Re: The Highland Companies Proposed Melancthon Quarry Application

TO: Fred Natolochny
FROM: Gregg Zwiers
CC:
RE: GRCA Hydrogeological Comments
Proposed Melancthon Quarry Application,
Hydrogeologic and Hydrologic Assessment,
Volumes 1 through 4

DATE: April 19, 2011

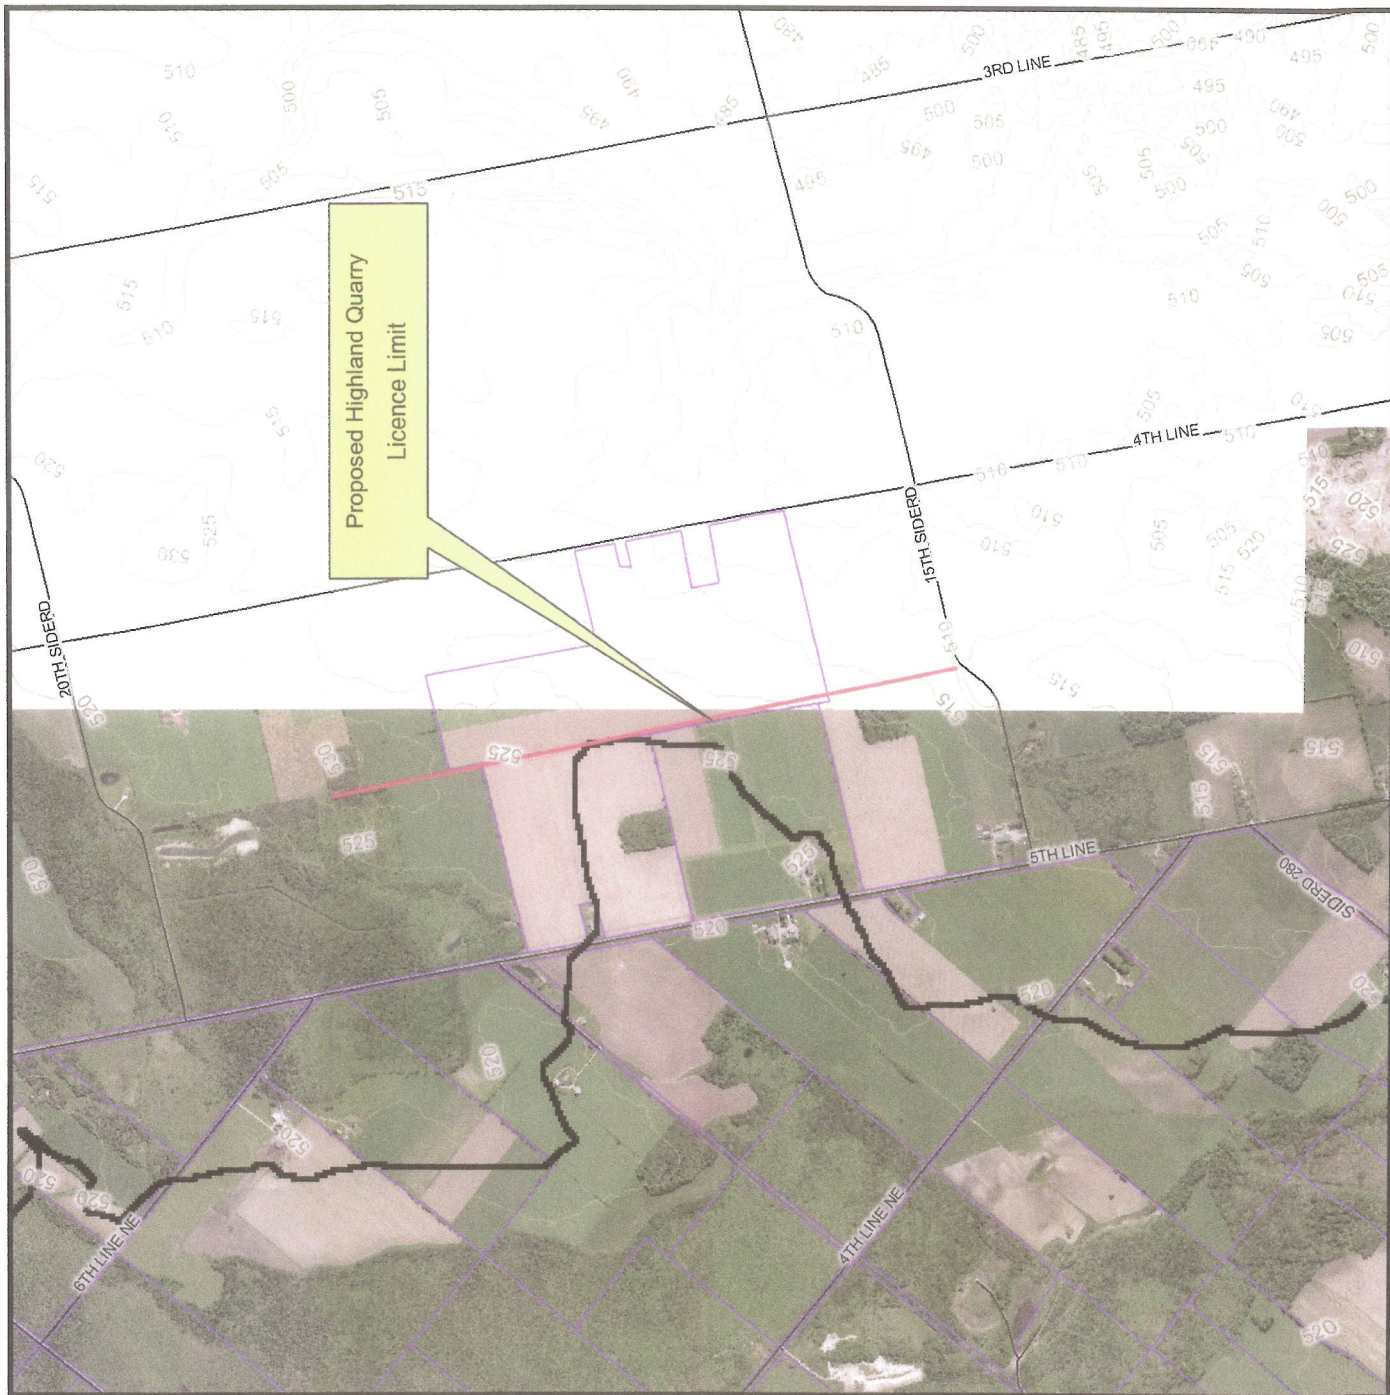
We do not agree with some of the information in the plans and reports relating to the jurisdictional boundary between the Conservation Authorities. The reports suggest that 2 hectares of the proposed licenced area is within the Grand River Conservation Authority. Our information suggests the licence limit is coincident with, or outside, our watershed boundary, as shown on the

attached sheet. The area in question is characterized as an internally drained depression area that does not directly drain to either watershed. As such, we believe the application is within the jurisdictional area of the Nottawasaga Valley Conservation Authority. However we have an interest in reviewing and commenting on the proposal as it has a potential to impact ground water resources within our watershed. Clarification on the jurisdictional boundary should be done in the near term by advising the applicant, and requesting additional clarification on the rationale for these statements.
